SITE PLAN

Elizabeth & Dan Ra[^] Home
8240 Piute Road
Colorado Springs, Colorado 80926

BUILDING	SITE PLAN
DRAWN BY:	DM
SCALE:	AS NOTED

Site Plan_v1-redline.pdf Markup Summary

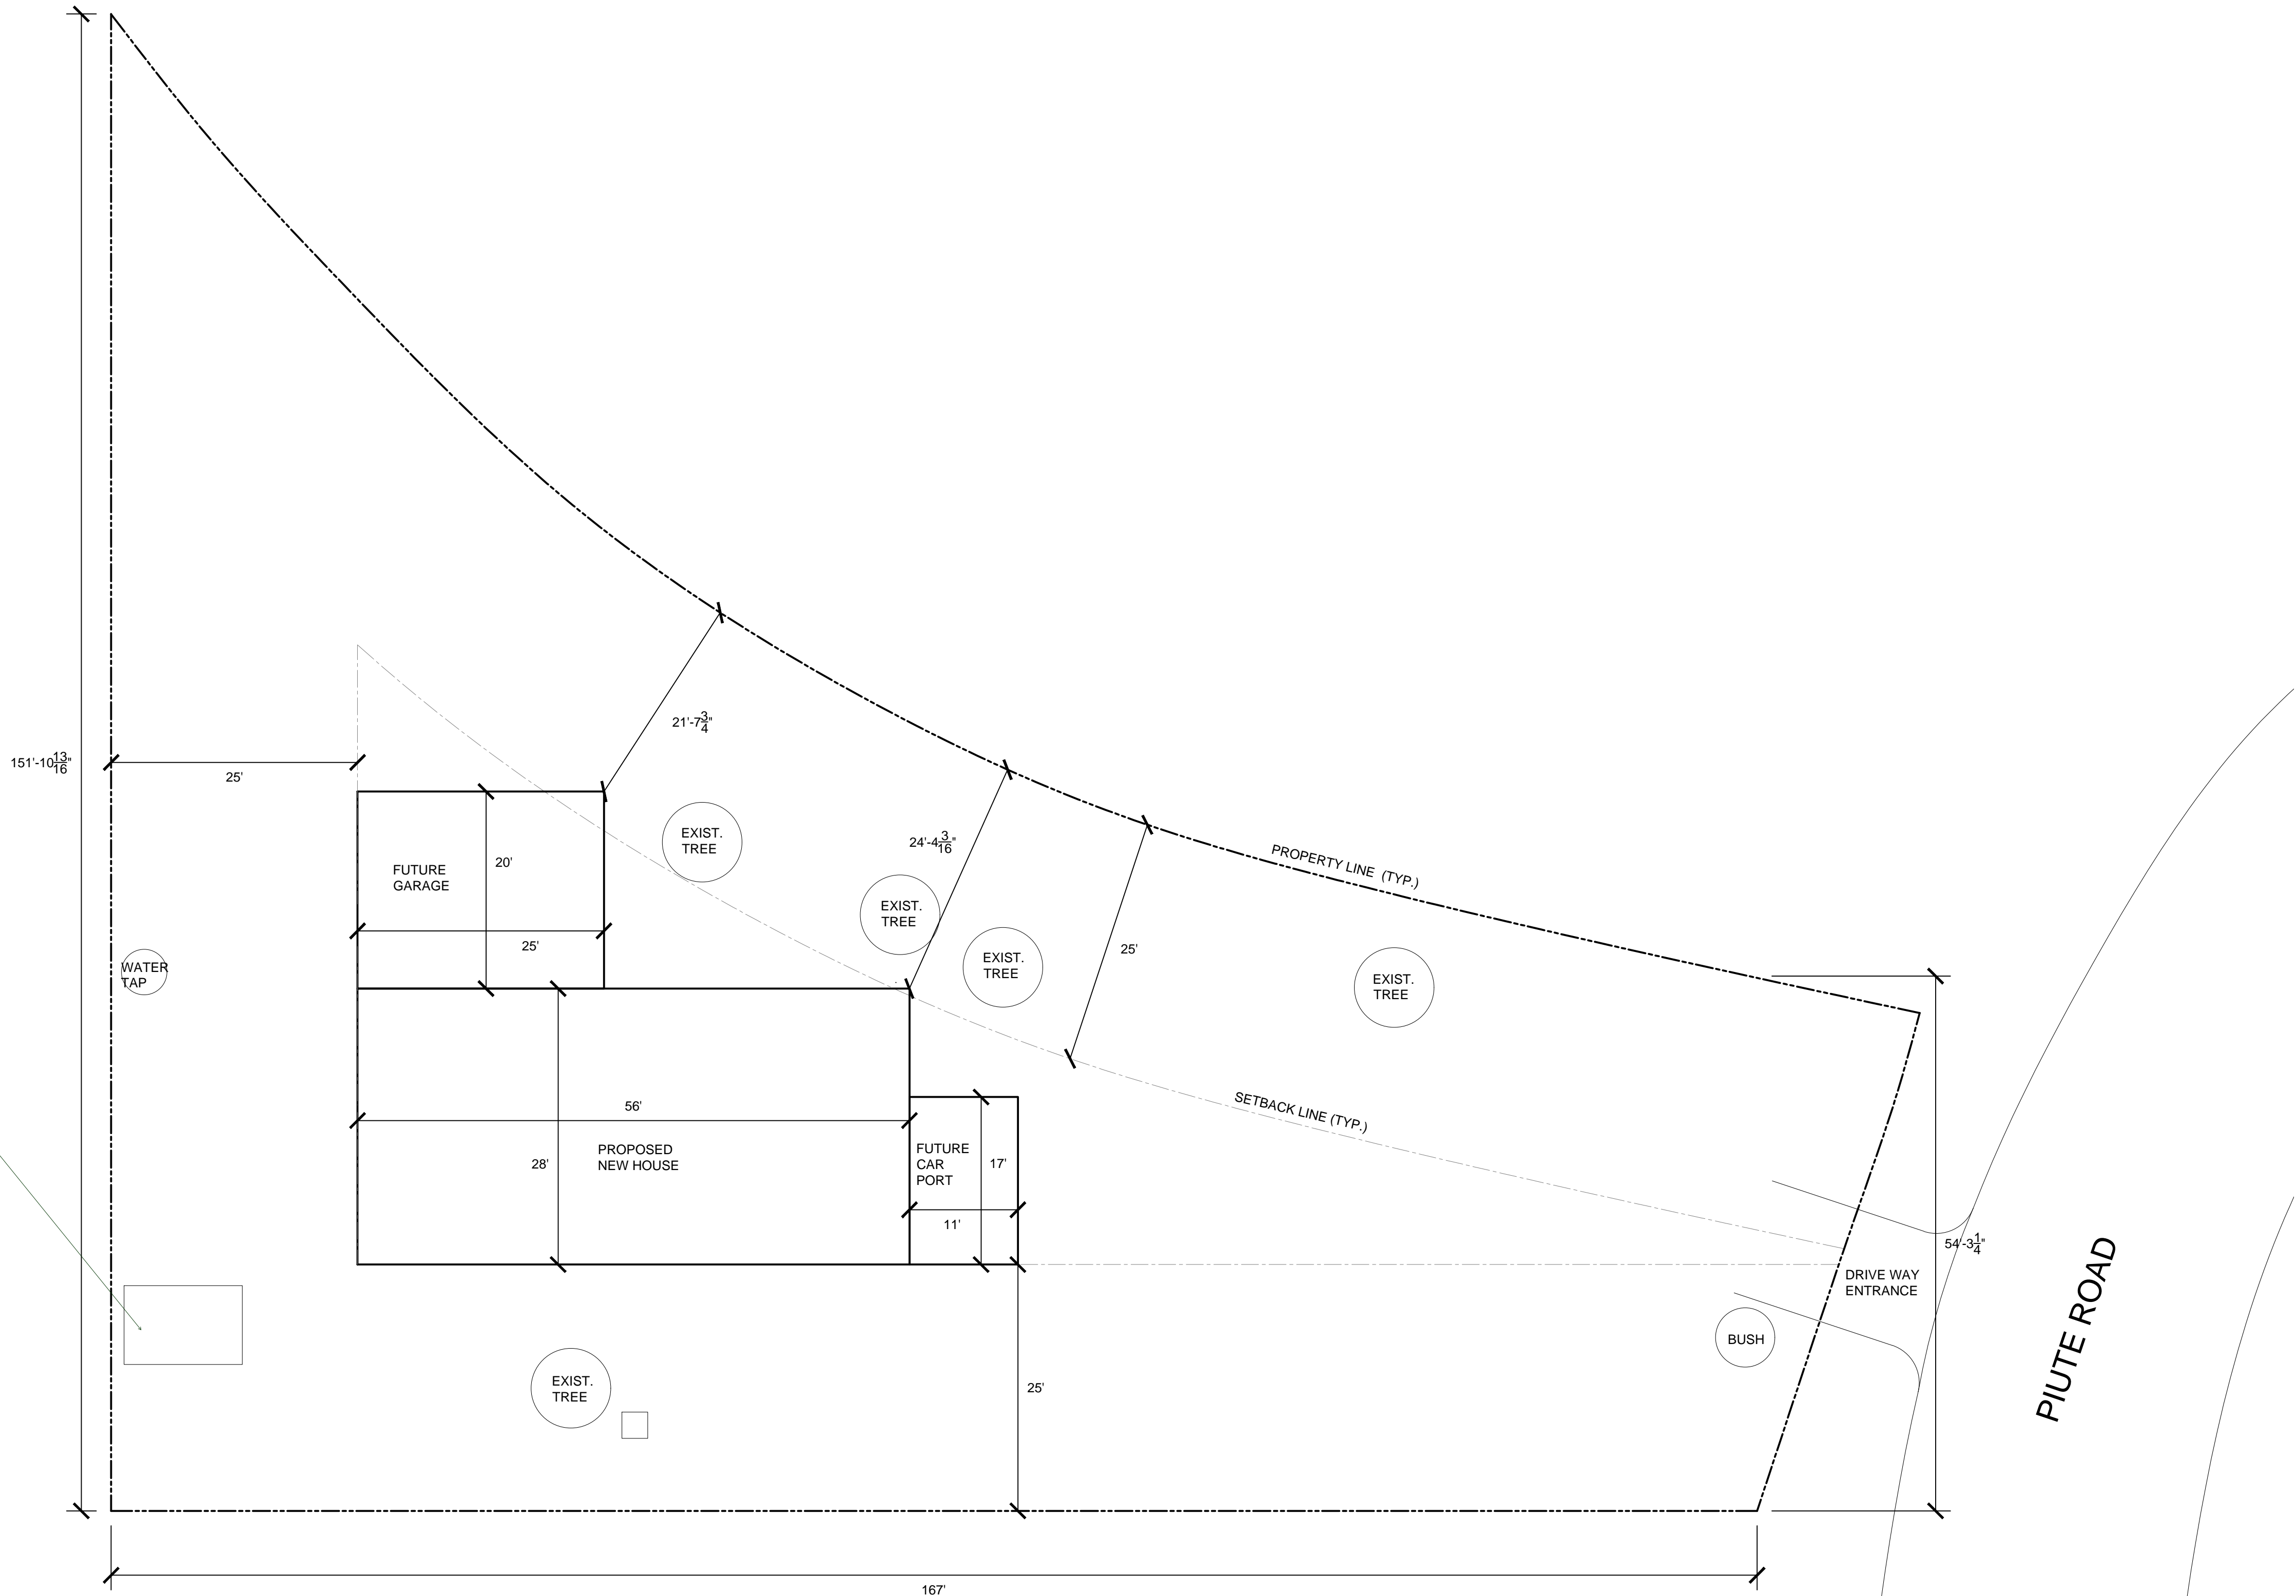
What is this?
